TX3 New -256 Products

A. Introduction

LT-6724-256 Rev 0 Page 1 of 7

Figure 2. TX3 devices on an Ethernet network - new configuration

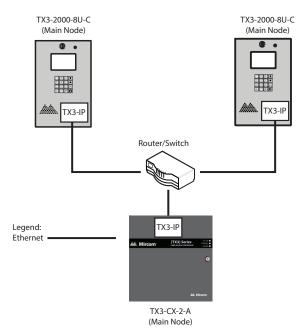
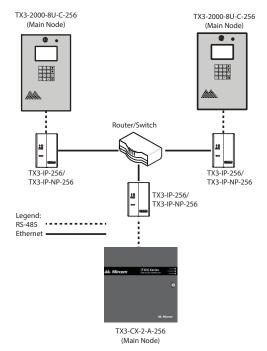
Models ending in -256 do not support the TX3-IP IP module.

As a result of this change, the method for connecting TX3 devices on an Ethernet network has changed.

Figure 1 shows the old method for networking TX3 devices in an Ethernet network. Each device has an internal TX3-IP module that connects to the Ethernet network.

Figure 2 shows the new method. The TX3-IP module is no longer used. Each device that is connected to Ethernet must have a TX3-IP-256 or TX3-IP-NP-256 IP adapter module connected to it by RS-485. The IP adapter module is a bridge between RS-485 on the device side, and Ethernet on the network side.

Figure 4. TX3 devices on a mixed network - new configuration

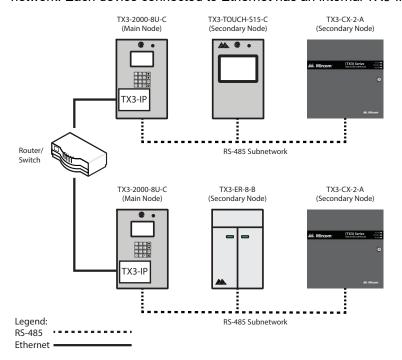
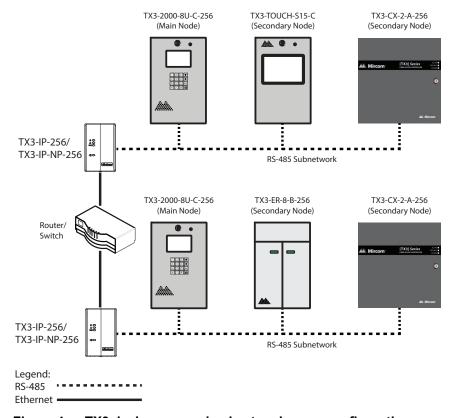
Figure 3 shows the old method for networking TX3 devices in a mixed RS-485 and Ethernet network. Each device connected to Ethernet has an internal TX3-IP module installed.

Figure 4 shows the new method for networking on a mixed network. The TX3-IP module is no longer used. Each device that is connected to Ethernet must have a TX3-IP-256 or TX3-IP-NP-256 IP adapter module connected to it by RS-485. The IP adapter module is a bridge between RS-485 on the device side, and Ethernet on the network side.

Figure 5. TX3-IP-256 and TX3-IP-NP-256

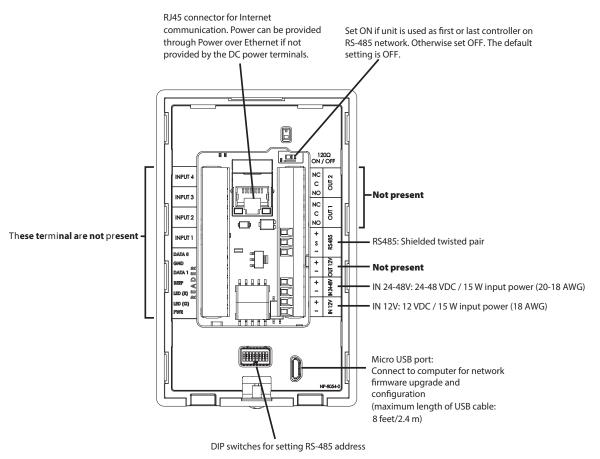
The TX3-IP-256 and TX3-IP-NP-256 serve as IP adapters for models ending in **-256**. They resemble the TX3-CX-1 and TX3-CX-1-NP single door controllers, but they have no door controller functionality. They are powered the same as TX3-CX-1 and TX3-CX-1-NP. Their mechanical installation is the same as TX3-CX-1 and TX3-CX-1-NP.
